RE: Comments for Proposed Development – Level III Review

Project:	Building Conversion	Project ID:	2018-011
Project Address:	415 Cumberland Ave.	CBL:	36-G-33
Applicant:	Sam Reiche		
Planner:	Christian Roadman

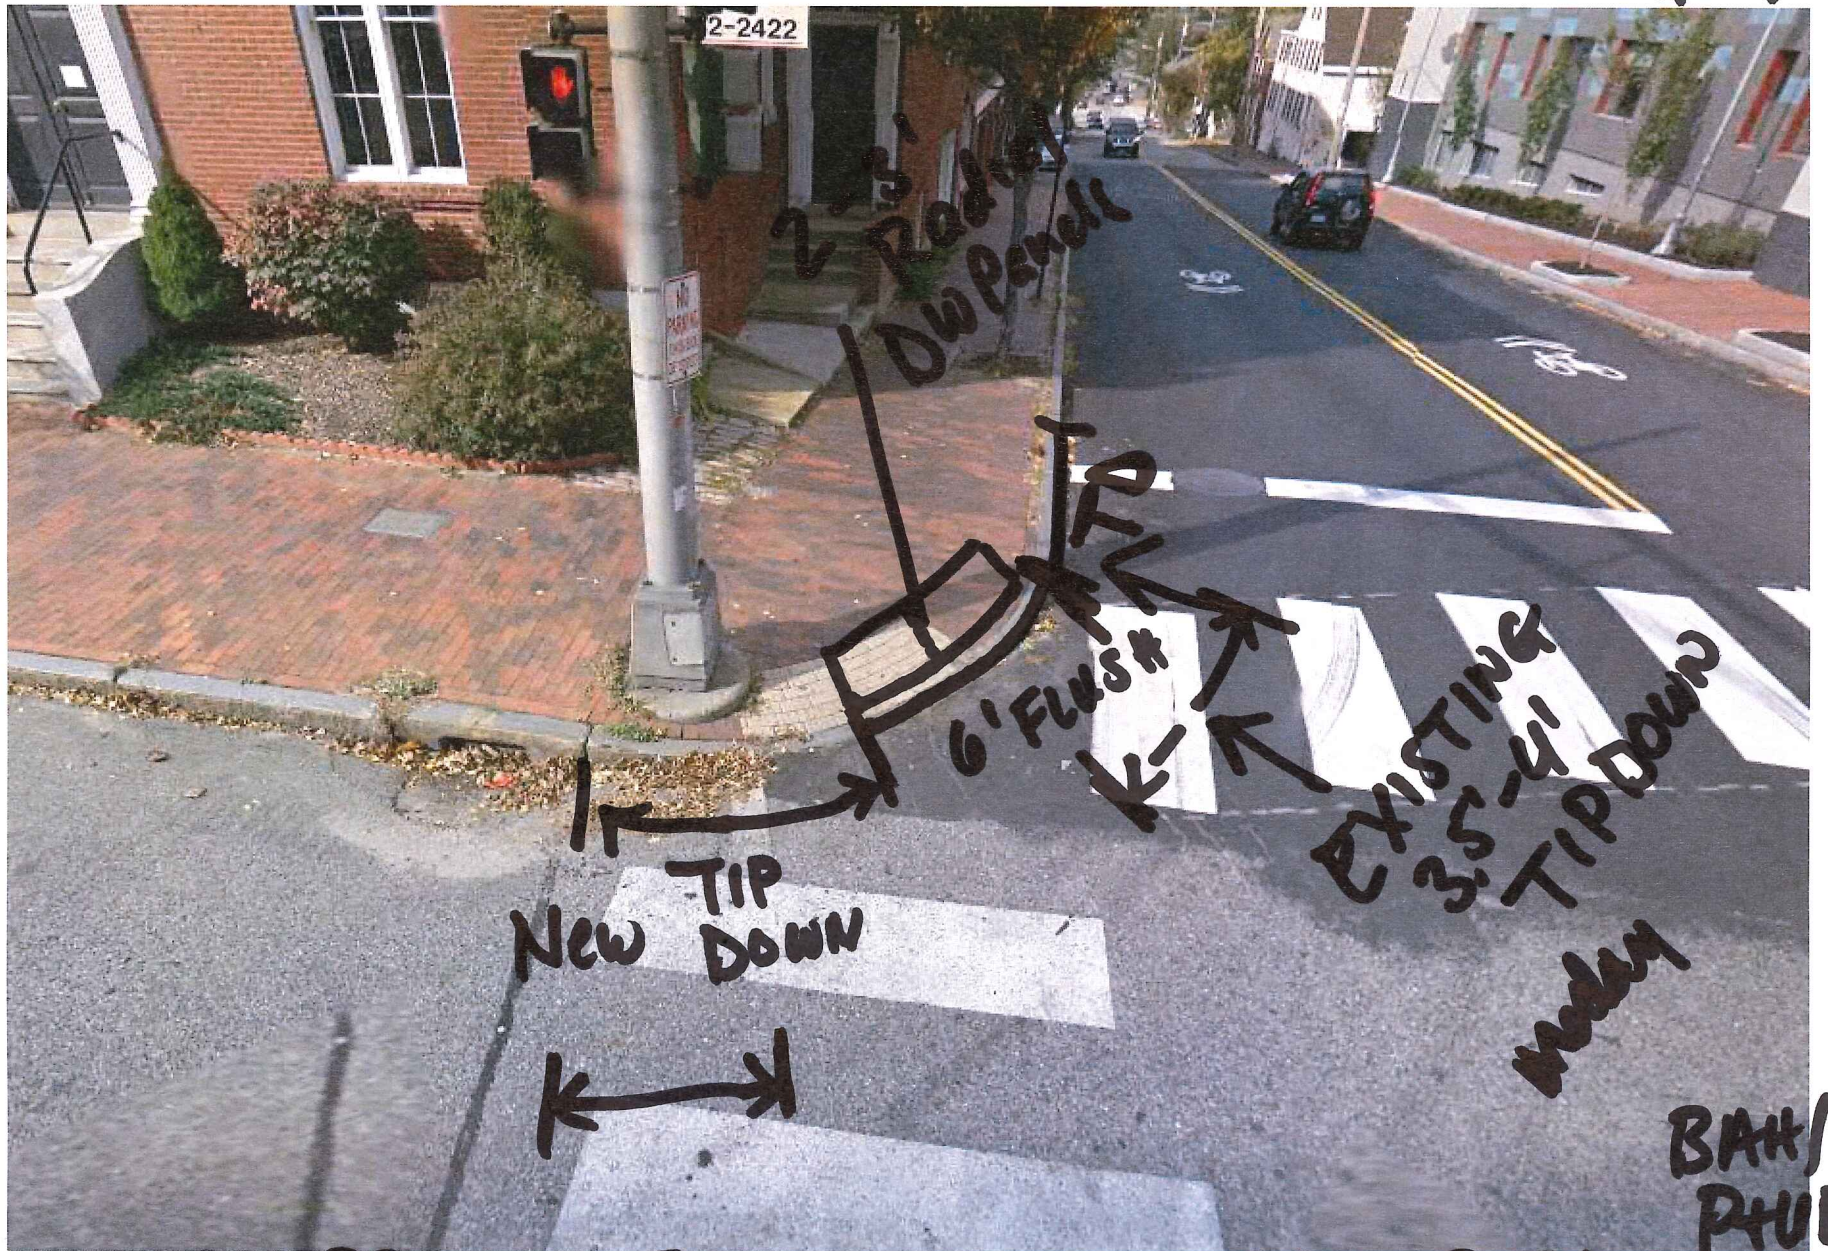
8. The curb ramp is to be updated to achieve full ADA-compliance and meet existing Technical Standards. Please see attached curb ramp configuration provided to the previous applicant's project team for this location. The current standard for the detectable warning panel with the curb ramp is cast iron with a 4" concrete border and is available from DPW if needed.

WILL PROVIDE BETTER ALIGNMENT TO BOTH RECEIVING CROSSWALKS
